## CAIRNGORMS NATIONAL PARK AUTHORITY

**Title: REQUEST FOR NON-MATERIAL  
VARIATION TO APPROVED PLANNING  
APPLICATION**

**DEVELOPMENT APPROVED: CONSTRUCTION OF NEW  
STORAGE / OFFICE BUILDINGS  
AND ASSOCIATED SITE  
ACCESS, DRAINAGE AND  
LANDSCAPING WORKS AT THE  
HIGHLAND FOLK MUSEUM,  
KINGUSSIE ROAD,  
NEWTONMORE**

**REFERENCE: 2011/0418/DET**

Fig. 2: Proposed site plan

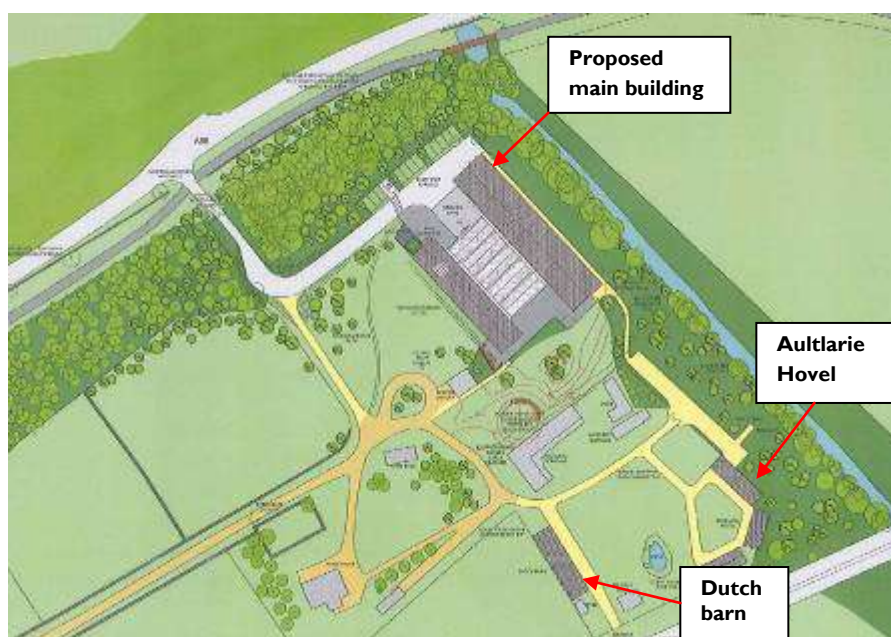
5. In summary the proposed changes from the approved scheme are:
  - Reduction in the overall height of the building by 550mm – combination of setting into ground and lowering roof.

- Removal of timber cladding to the pitch roofs and substitute with use of mill finished standing seam aluminium cladding.
  - Removal of sedum roof and small pitched bays in the central link section and substitute with a flat roof clad in light grey membrane.

- Use of randomised rainscreen cladding in lieu of harling and ivy on the north east elevation
6. The package of proposals also includes a request that the proposed colours and materials are confirmed for the external windows and doors, timber cladding, rainscreen cladding and roofing materials as required by Condition 5 of the Planning Permission.

9. In summary her conclusions are:
  - Lowering the building will make no visible difference in landscape terms.
  - The use of profiled aluminium sheeting on the main roofs is acceptable, but there are concerns over the enduring high reflectivity of a milled finish and a coating to give an artificially weathered finish is recommended.

- Removal of the sedum roof, revision of profile of the flat roof and colour of finish are acceptable.
  - The changes to the roofs will allow heights to be dropped which will be a visually significant gain in terms of the overall mass of the building and its setting in the landscape.

- The use of rainscreen cladding on the north east elevation is acceptable, but after looking at examples of weathered larch request that the

colour portfolio for randomising be altered to include more than one colour and have a lighter tone.

12. **That Members of the Planning Committee agree to the request for the Non-Material Variation to Planning Permission 2011/0418/DET subject to:**
  - a) **The aluminium cladding to the roof being given a coating to reduce reflectivity in accordance with details to be agreed with CNPA.**
  - b) **The colour portfolio for the rainscreen cladding be revised to include more than one colour and have an overall lighter tone with details to be agreed with CNPA.**
  - c) **All other materials to be agreed with CNPA in accordance with the Conditions on the planning permission.**
